GULF STATES UTILITIES COMPANY

River Bend Station - Unit 1
Refer to: Region IV
Docket No. 50-458/90-27

REPLY TO NOTICE OF VIOLATION 50-458/90-27 LEVEL IV

ATTACHMENT 8.6

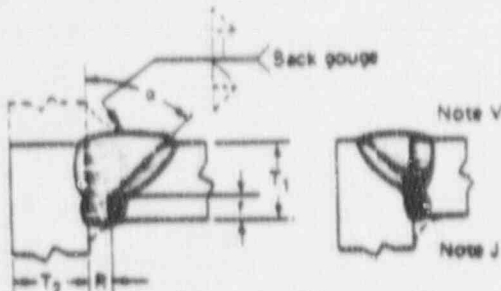
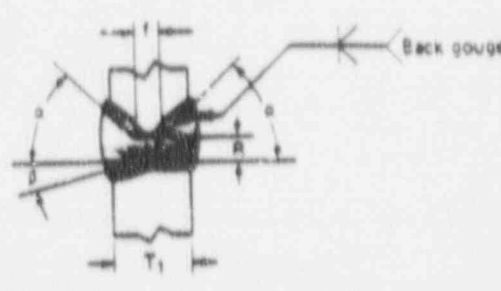
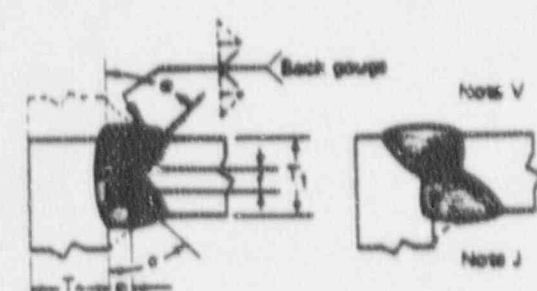
Contrary to the above, WPS-W1.1-01, which was designated as an AWS D1.1 prequalified welding procedure, was utilized in an application where the weld joint details did not conform to the requirements of Section 2 of the Code. Specifically, the joint configuration used for welding the flange to outer plate on a modification to the diesel generator tornado damper separator (Modification Request 86-1389) did not conform to the Section 2 prequalified joint details for included angle, thereby invalidating the procedure as prequalified. It was also determined that General Welding Procedure SPP-7002, Revision 1, which was referenced in WPS-W1.1-01 for joint fitup tolerances was inconsistent with the requirements of Section 2 of the Code; for example, the allowable root opening for Joint A-TC-U4a in SPP-7002 exceeded that permitted by the AWS D1.1 Code for a prequalified joint.

For the example referenced in the Notice of Violation, joint detail A-TC-U4a has been revised under Revision 2 of procedure SPP-7002 to be designated as joint "TC-U4a" (attached). This detail lists the combined allowable joint variations as:

α = groove angle = 40° to 65°
R = root opening = 0 to $1/4"$
f = root face = NL (not limited)

As can be seen these allowable joint variations are identical to those identified in Attachment 6 of SPP-7002. GSU has identified no inconsistencies in SPP-7002 with respect to AWS D1.1 prequalified weld joint details.

Fig. 3.3.4—Workmanship tolerances in assembly of groove welded joints

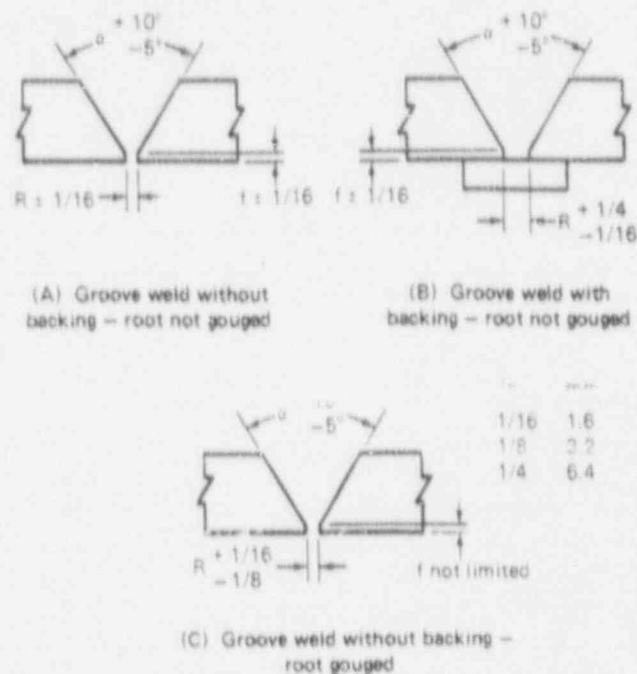
Groove prep	As detailed 2.9.2	As fit-up 3.3.4
R = 0 to $1/8$	$+1/16, -0$	$+1/16, -1/8$
f = 0 to $1/8$	$+1/16, -0$	not limited
$\alpha = 45^{\circ}$	$+10, -0$	$+10, -5$

The groove preparation and tolerances when combined provide for the following allowances:

$\alpha = 40^{\circ}$ to 65°
R = 0 to $1/4"$
f = not limited
